BRIDGE 52 STREAM DIVERSION PLAN  
SCALE 1" = 20'-0"

SHEET NAME: BRIDGE 52 STREAM DIVERSION PLAN		
PROJECT NAME: WINHALL		SHEET NO. 1 OF 4
PROJECT NO: STP CULV (31)		
DRAWN BY: CE	CHK'D BY:	DATE: 04/21/2015

**From:** Jacqueline Dagesse [<mailto:jdagesse@eivtech.com>]  
**Sent:** Wednesday, April 29, 2015 7:20 PM  
**To:** Lemaire, Ron  
**Cc:** Farley, William; Mackintosh, Mark  
**Subject:** Winhall STP CULV(31) Water Diversion Plan Submittal

We completed a cursory review of the Winhall STP CULV (31) Water Diversion Plan and have the following comments:

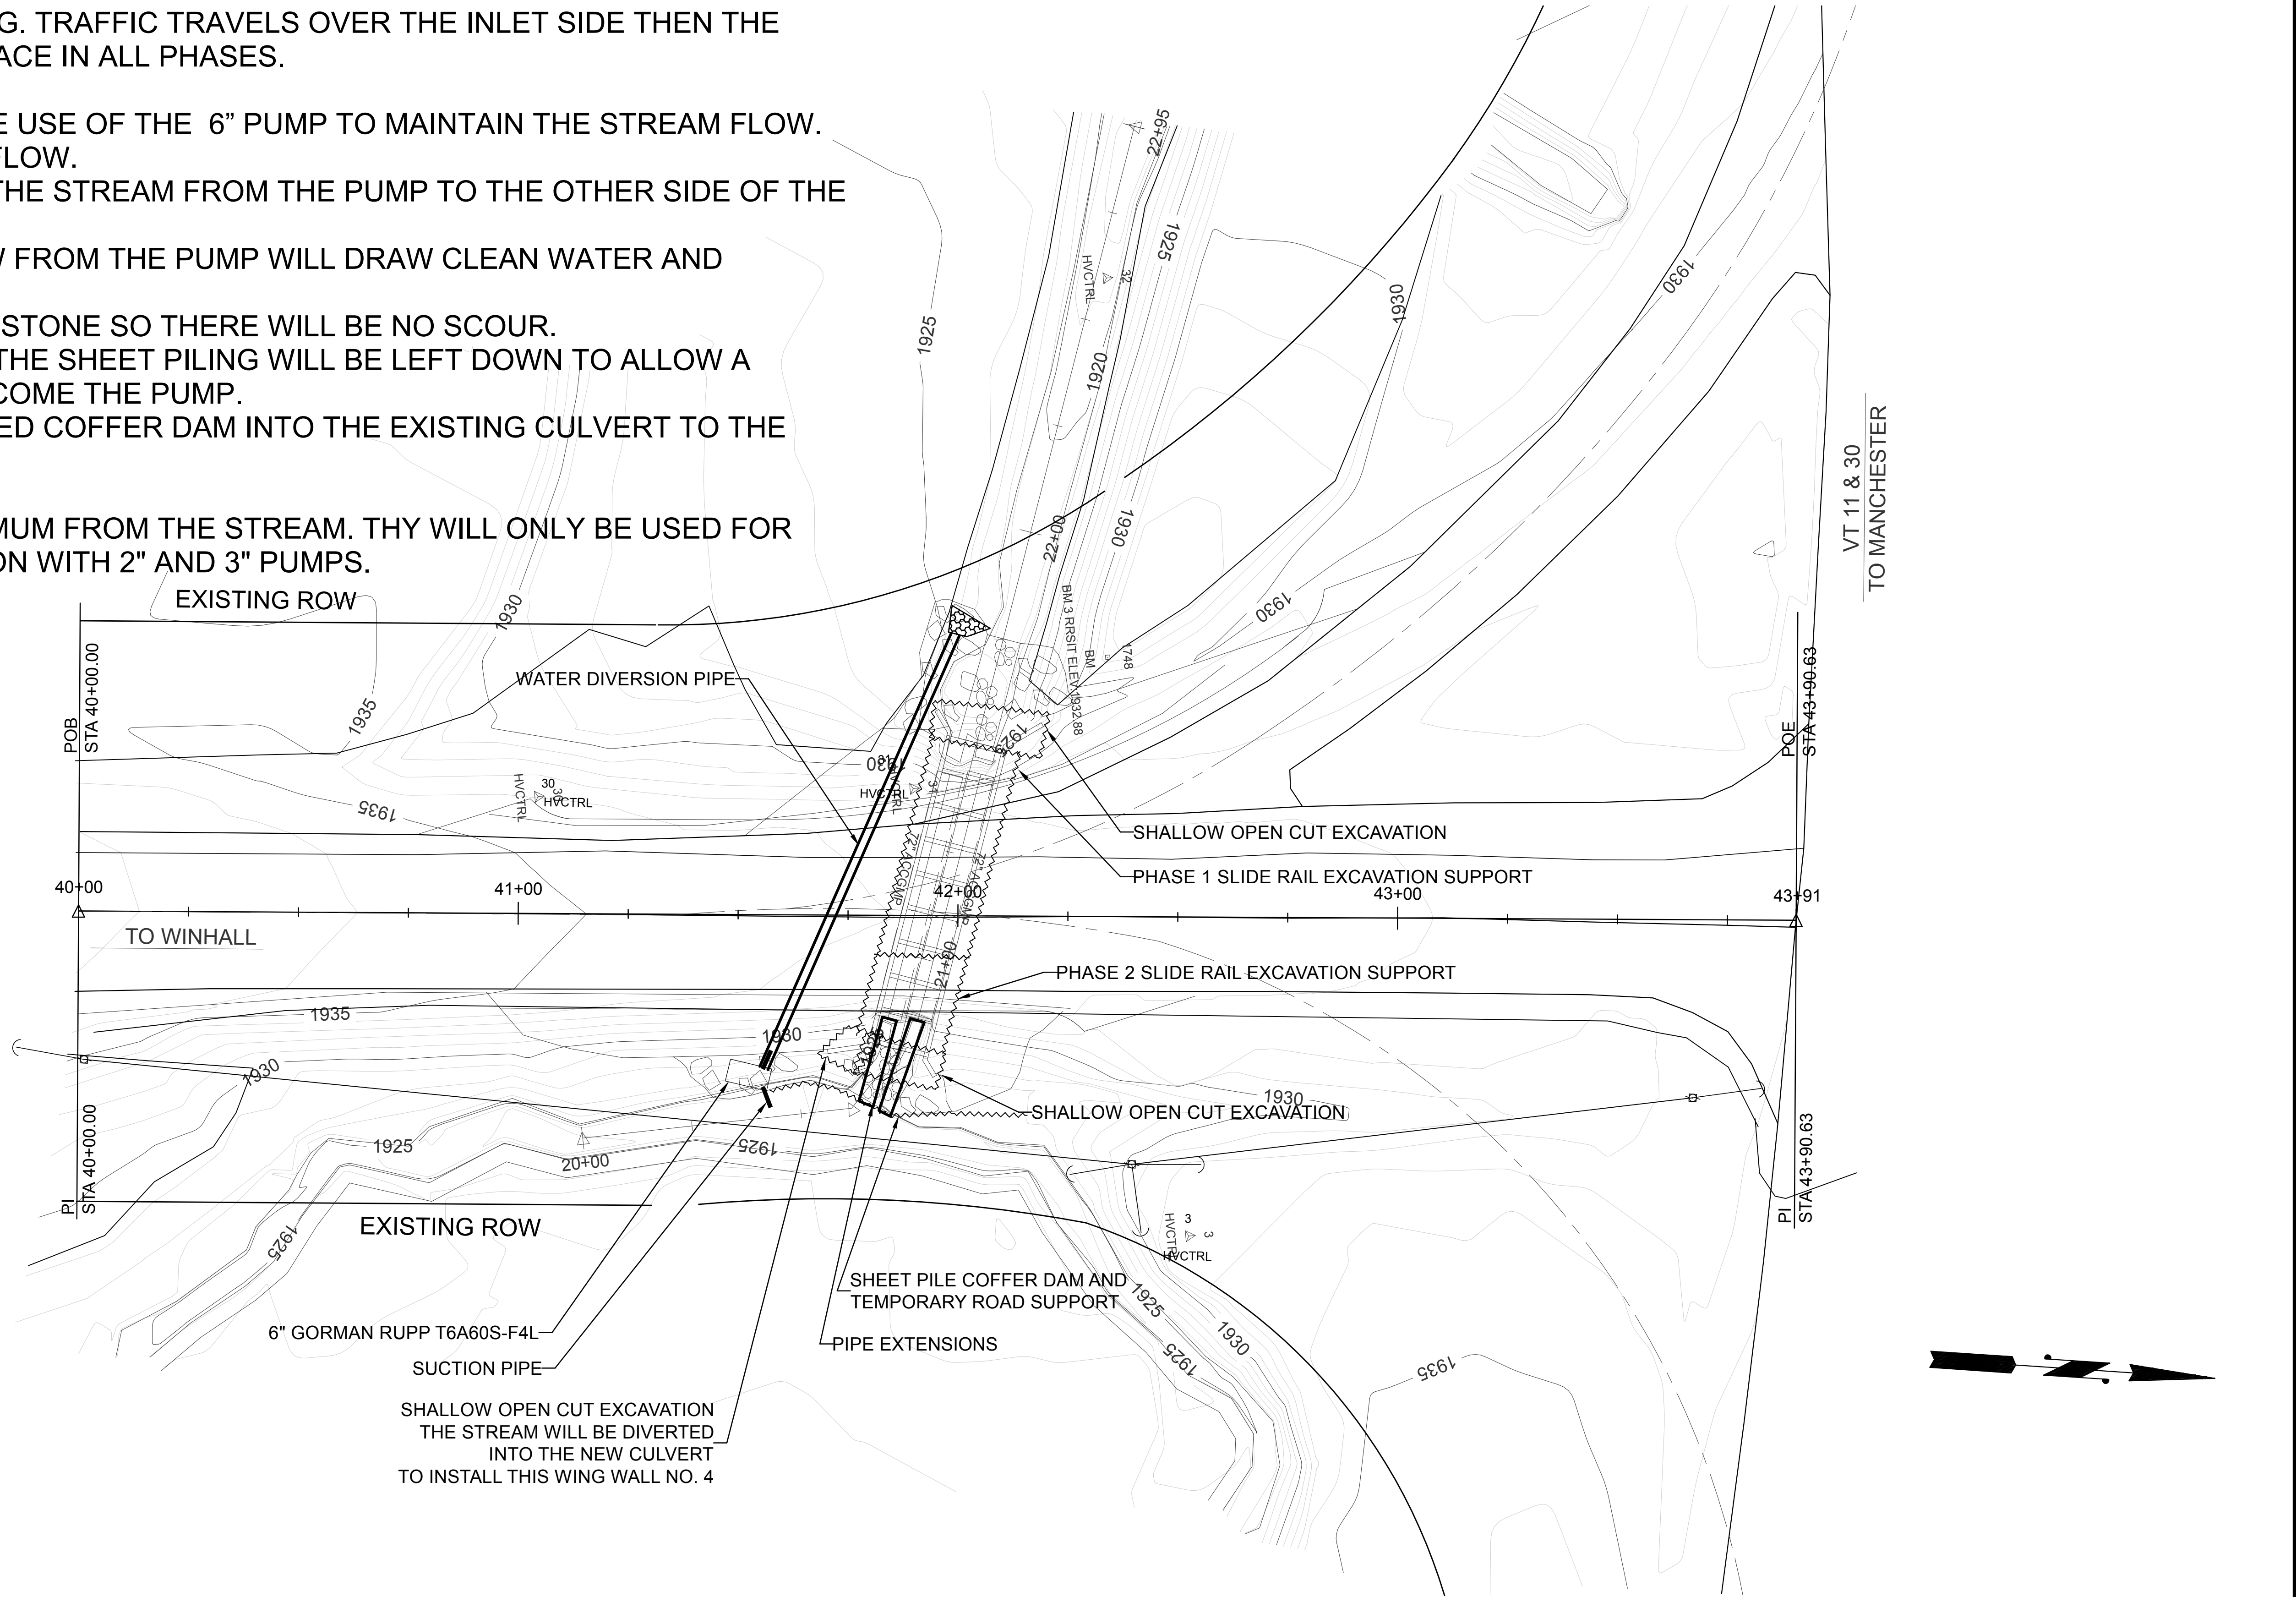
- Renaud Brothers mentions using a 6" pump for dewatering. What size event would this pump be able to handle?
- Where are they dewatering to? Using a filter bag? What is the backup plan?
- The plansheets that they provide need to have resource information, stationing and north arrow.
- We need a more detailed description of what they plan to do.

SEE THE STREAM DIVERSION PLAN FOR THE USE OF THE 6" PUMP TO MAINTAIN THE STREAM FLOW. THE 6" PUMP WILL HANDLE THE 25cfs OHW FLOW. THE PIPE LAID ACROSS THE ROAD CARRIES THE STREAM FROM THE PUMP TO THE OTHER SIDE OF THE ROAD. BY BUILDING AN ADAQUATE POND TO DRAW FROM THE PUMP WILL DRAW CLEAN WATER AND DISCHARGE CLEAN WATER. THE CLEAN WATER WILL DISCHARGE ONTO STONE SO THERE WILL BE NO SCOUR. AT THE INLET OF THE EXISTING CULVERTS THE SHEET PILING WILL BE LEFT DOWN TO ALLOW A RELIEF FOR THE STREAM SHOULD IT OVERCOME THE PUMP. THE STREAM WILL FLOW OVER THE LOWERED COFFER DAM INTO THE EXISTING CULVERT TO THE NEW CULVERT AND BACK TO THE STREAM.

THE FILTER BAGS WILL BE PLACED 50' MINIMUM FROM THE STREAM. THY WILL ONLY BE USED FOR LOCALIZED PUMPING FROM THE EXCAVATION WITH 2" AND 3" PUMPS.
